SUPERIOR COURT  
CIVIL ACTION NO. 06-0790 C

**JOINT MOTION BY THE PARTIES TO FILE A REVISED EXHIBIT 2 TO THE FINAL CAD APPENDED TO THE SETTLEMENT AGREEMENT, A NEW EXHIBIT TO APPENDIX A OF THE SETTLEMENT AGREEMENT, AND TO REVISE TWO PARAGRAPHS IN THE FINAL JUDGMENT**

Reference: Crow Lane Landfill Corrective Action Design; Newburyport, Massachusetts  
Summary of Slope Stability Analysis Performed for Concept C Revised Grading

Slope Stability Analyses Performed by McPhail Associates, Inc.

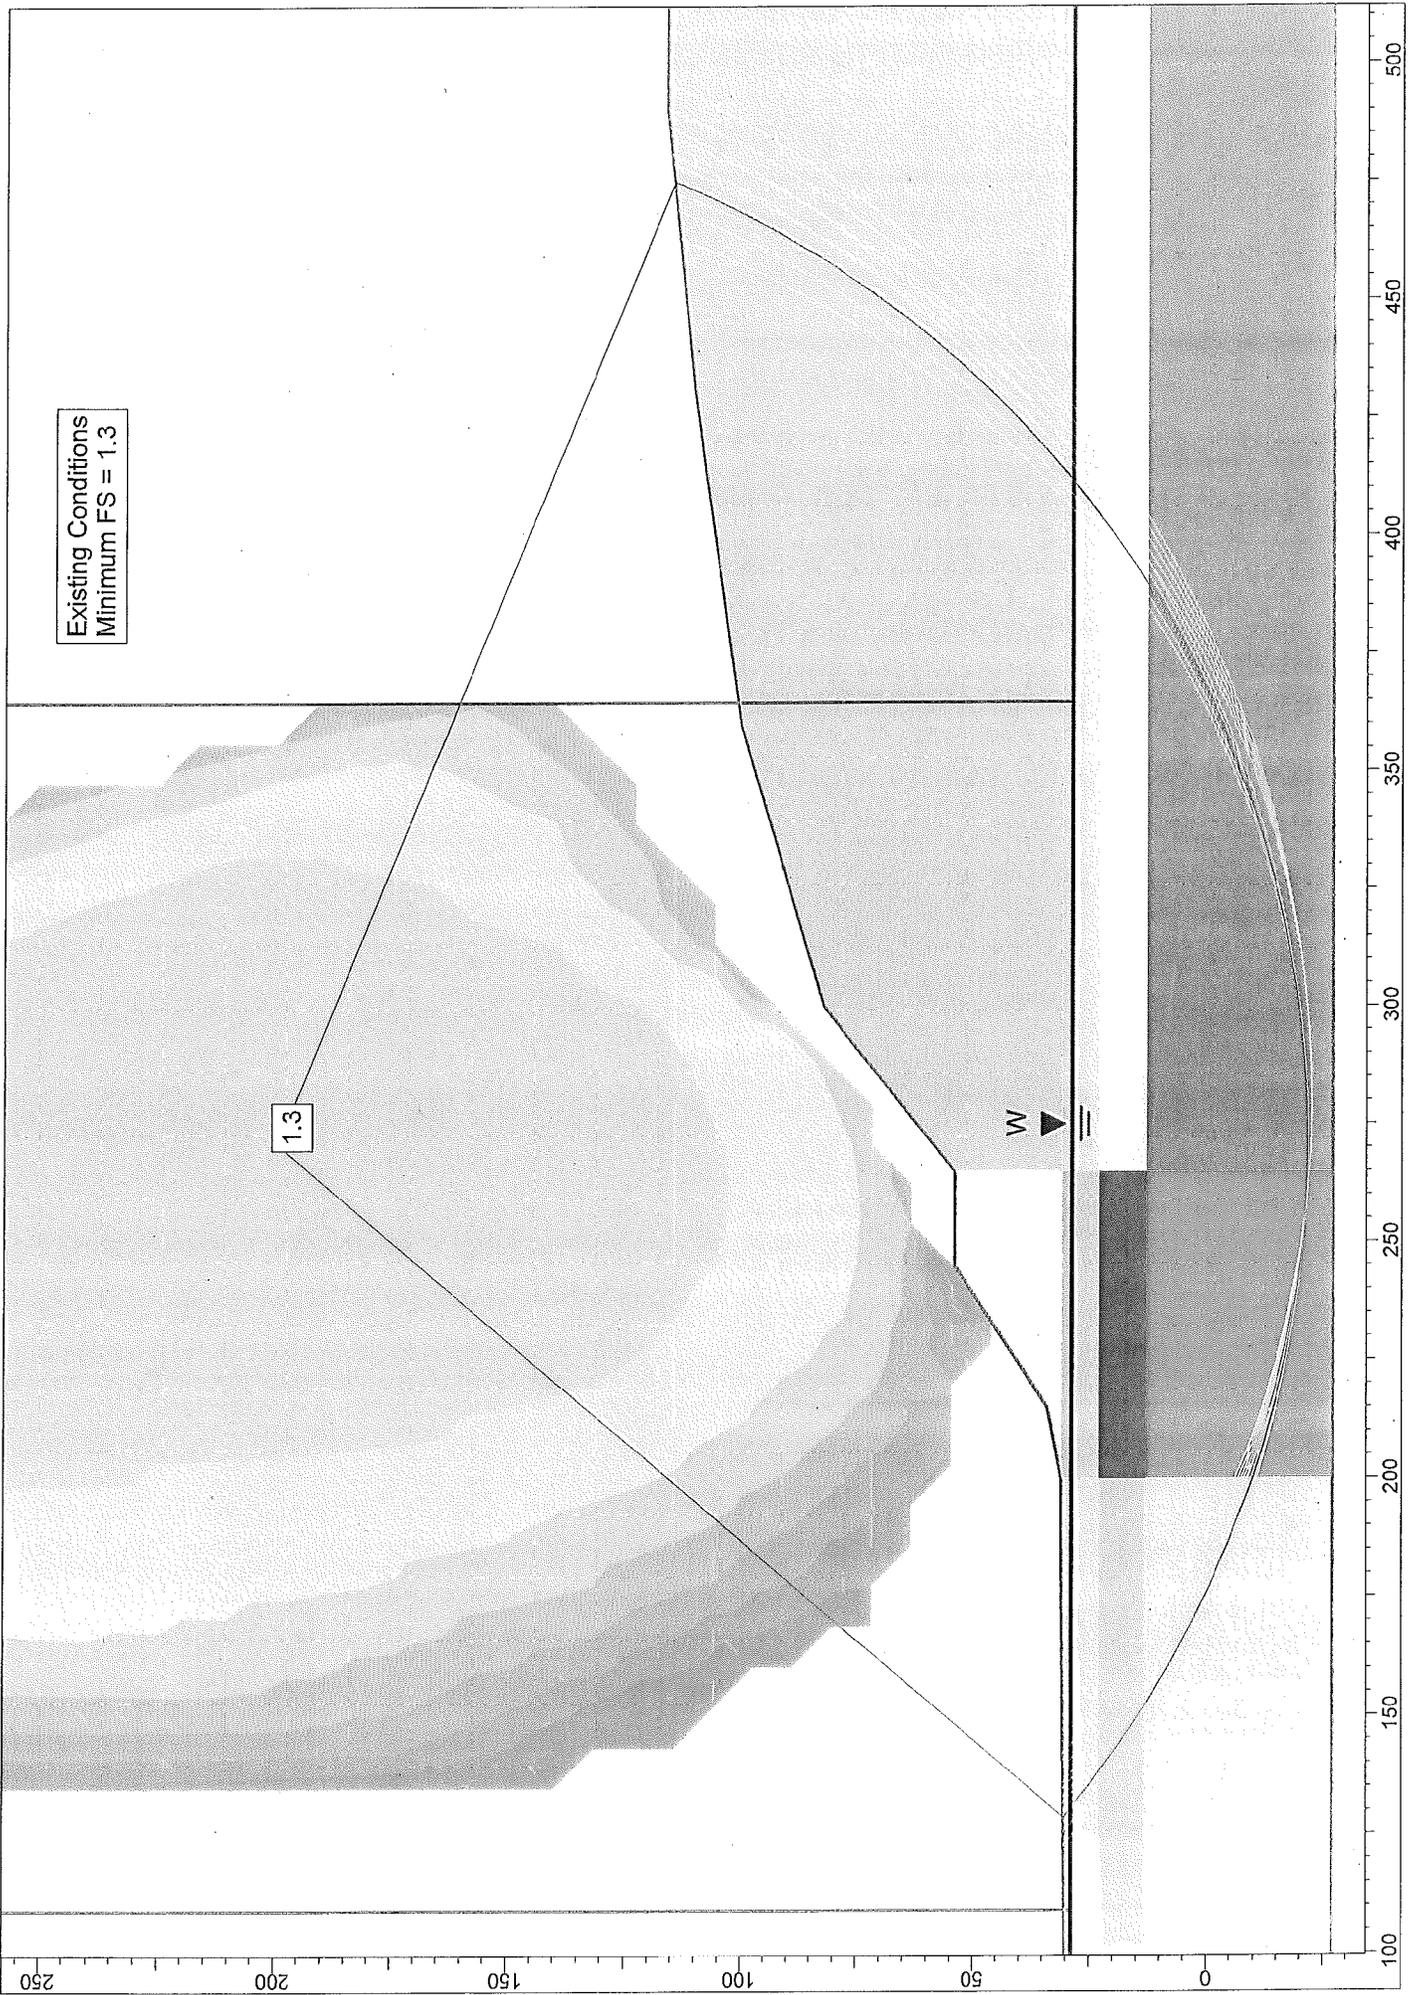
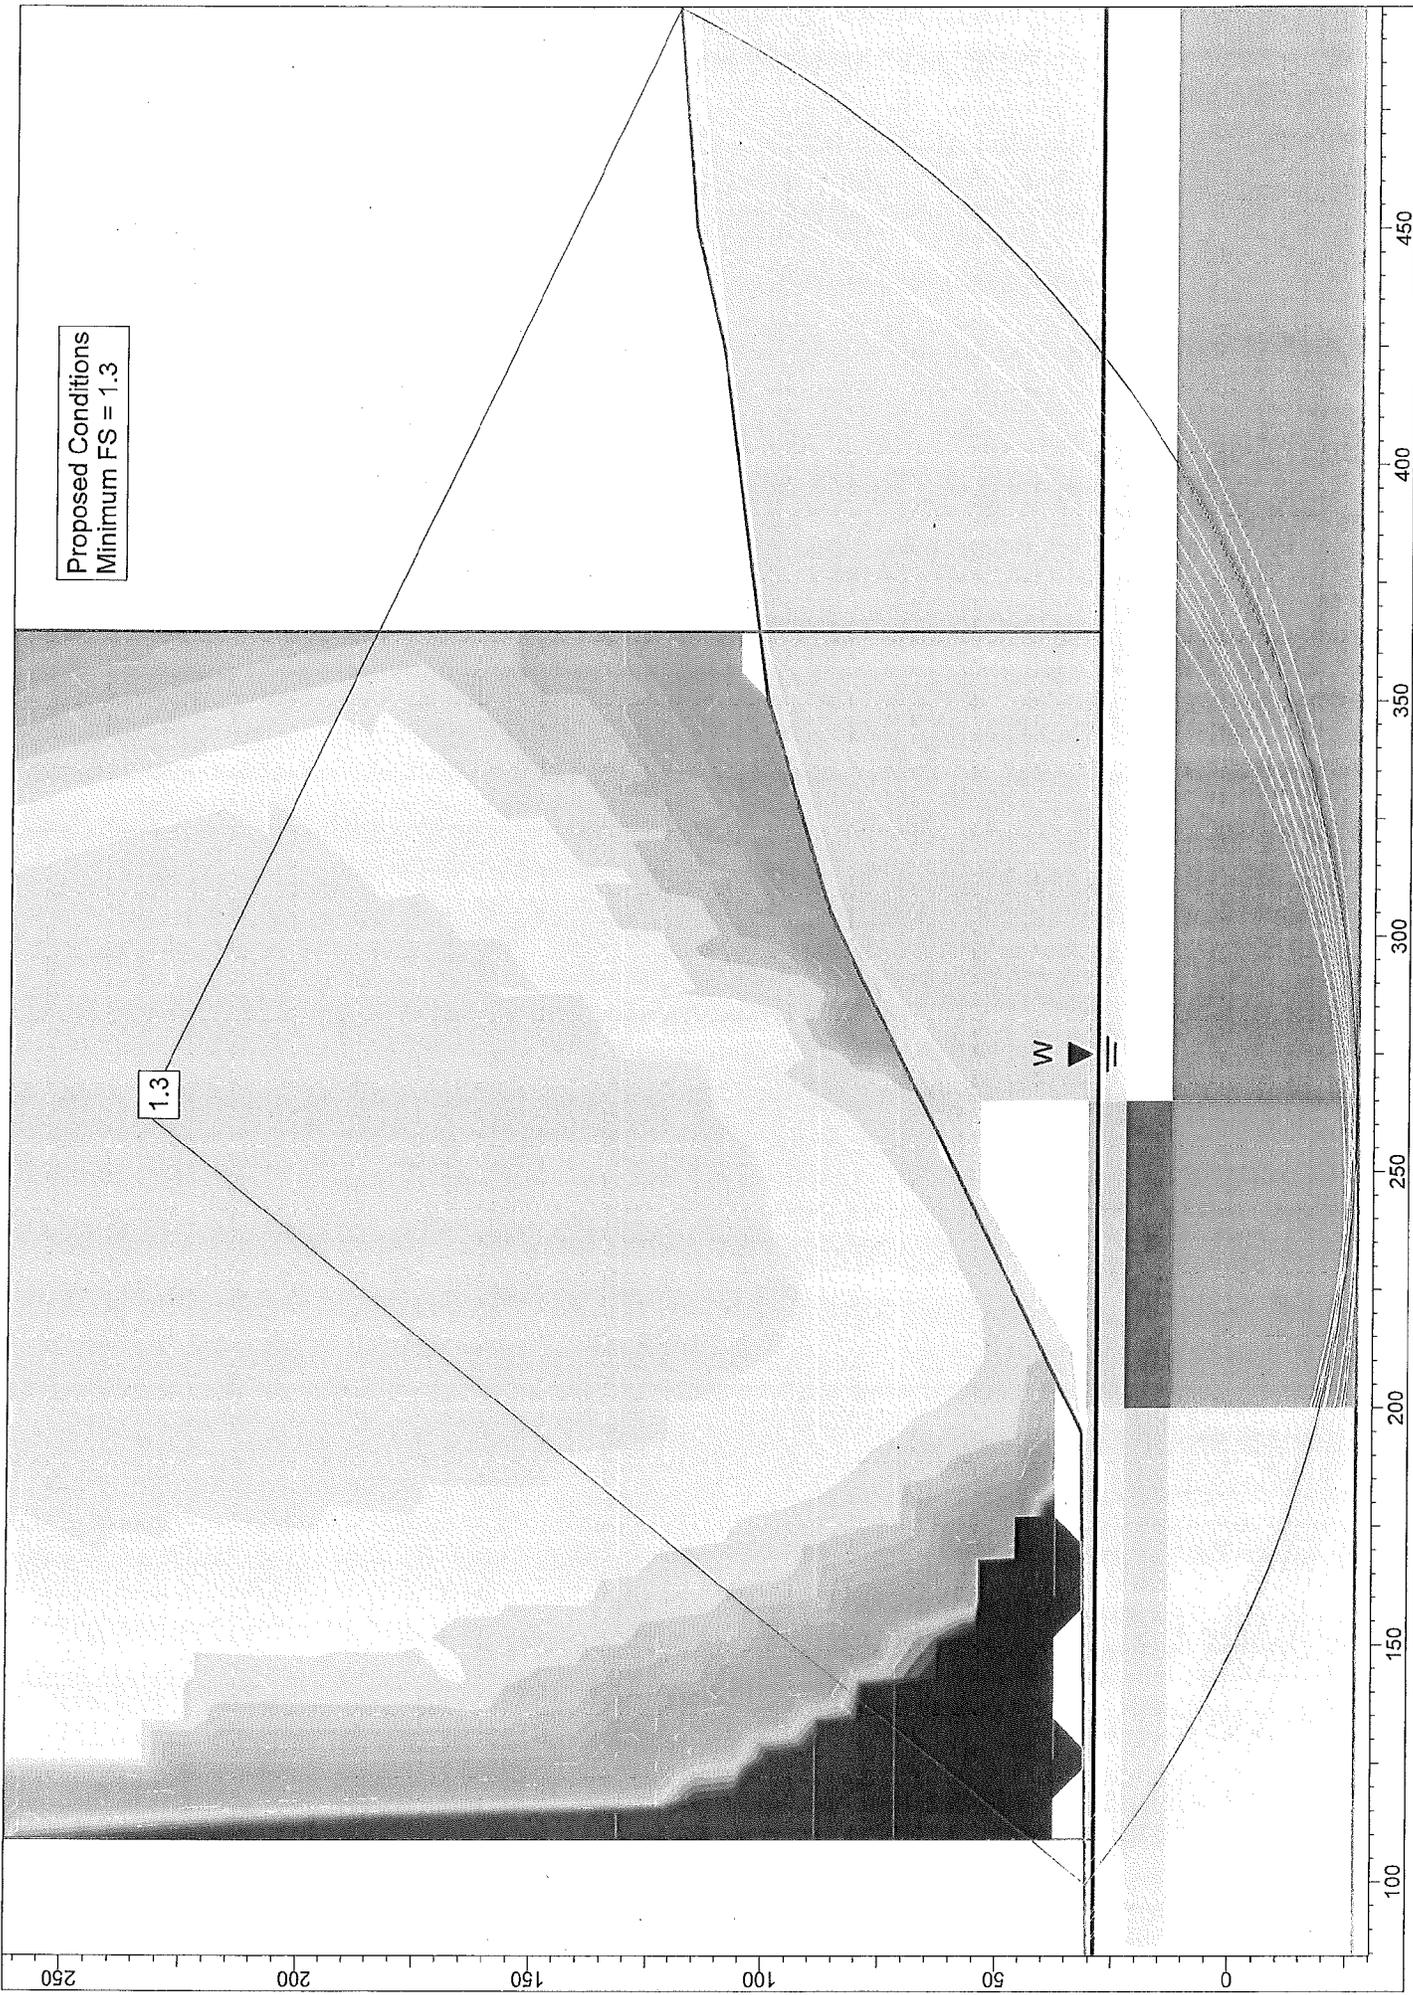
The current proposed corrective action design (Concept C) includes the construction of a 2 horizontal (h) to 1 vertical (v) berm in front of the existing berm. The top of the 2 h to 1 v berm would be at approximately Elevation +86.5. In addition to the proposed landfill cap, portions of the existing landfill above Elevation +86.5 would be flattened to an approximate 3 h to 1 v slope by adding soil.

The existing and proposed berm geometries at Section A-A were obtained from site plans provided by SITEC on September 2, 2010. The soil properties utilized in the slope stability analyses are the same as those utilized in our previous analyses included in our June 10, 2010 letter.

The two-dimensional slope stability computer program SLIDE developed by Rocscience, Inc. was utilized to compute the factor of safety (FS) for existing and proposed conditions. The Bishop Simplified and Spencer Methods of determining the FS were utilized. The results of our slope stability analyses are attached herein in Appendix A.

In accordance with US EPA guidelines for the design of land disposal facilities, developed under RCRA Subtitle D, a FS greater than or equal to 1.25 is considered acceptable for slope stability analyses during construction when site specific soil properties are available. We understand that according to the settlement agreement of April 2009, the required minimum factor of safety is 1.3. The computed minimum factor of safety for the existing conditions is 1.3. The computed minimum factor of safety for the proposed conditions is also 1.3. Therefore, based on our slope stability analyses, construction of the 2 h to 1 v berm will not significantly change the factor of safety against slope failure from the existing conditions. The proposed berm can be constructed immediately without further laboratory soil testing or instrumentation because the proposed earthen berm geometry in Concept C does not decrease the factor of safety against slope failure from that of the existing conditions.
